TOWN OF VIENNA, VIRGINIA

WALL WAIVER REQUEST

NAME OF PROJECT: Cadence on Center ACREAGE: 1.03 Acres

Re: Cadence on Center Property  
Request for a Waiver of the Masonry Wall Requirement

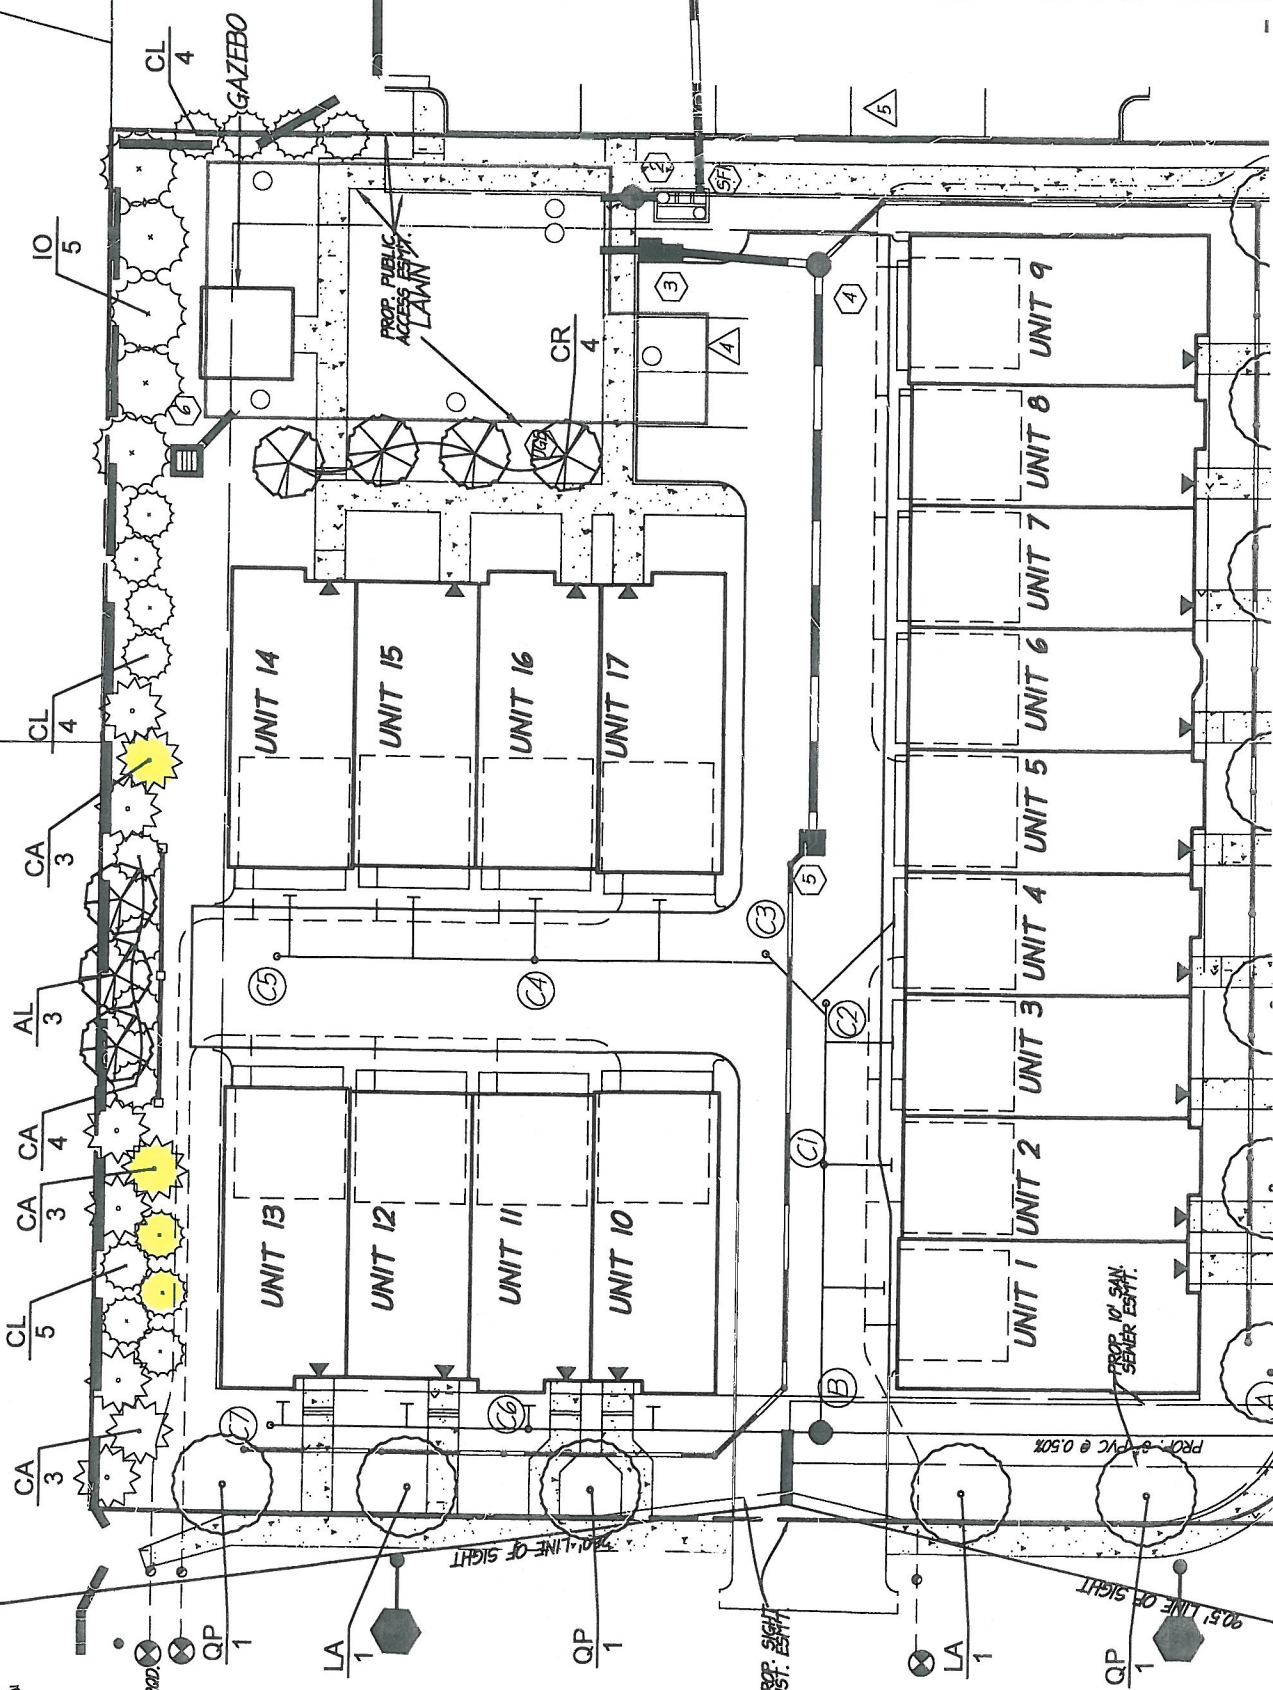
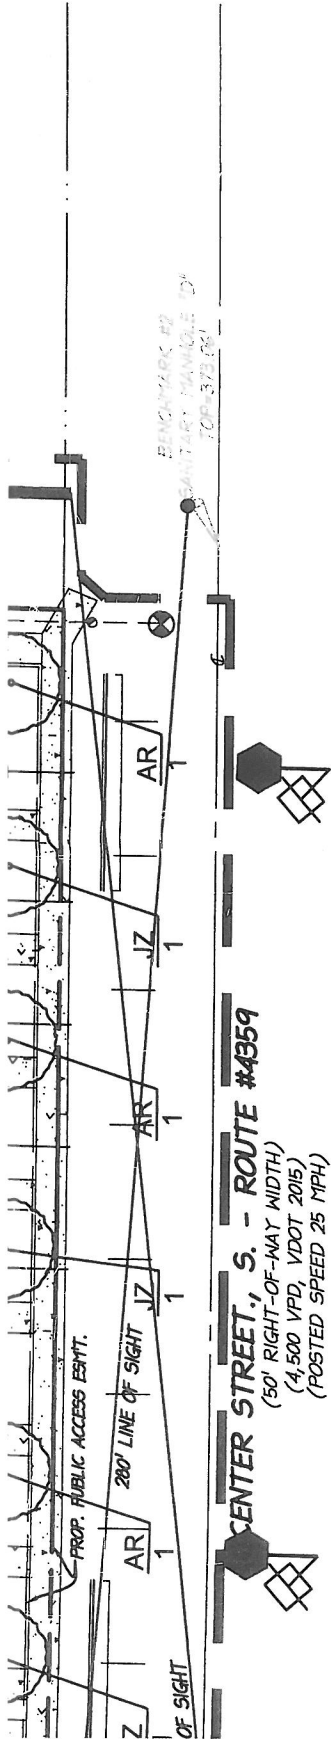
The Applicant respectfully requests your review and approval of a waiver Zoning Ordinance requiring the construction of the masonry wall in lieu of additional landscaping and larger tree sizes from the approved plan as attached. Our justifications for the request are as follows:

1. The current western boundary contains a six (6) foot tall wood fence on the common boundary providing ample screening.
2. The trees on the approved plan are 2" – 2 ½" caliper and/or 6'-7' tall trees.

3. The current masonry wall on the approved site plan will provide no further screening than the existing wood fence (see attached photo).
4. The current masonry wall on the approved site plan will be detrimental to the roots, growth and trimming of the proposed landscaping.

5. The applicant is proposing to add four (4) additional evergreen trees for screening as well as increasing the size of the all the Evergreen trees to the larger from 6' – 7' size to 8' – 10' size to provide a more immediate screening (see attached plan).

6. The applicant is proposing to install a 45-foot section of 6-foot-tall masonry wall at the end of the turnaround to make ensure that vehicular lights do not shine onto the neighbor's yard.

8. The applicant, per the neighbors and the Town of Vienna Arborist suggestions, move the trees away from the property line, change the species to native species and placed the new trees in the more desired locations.
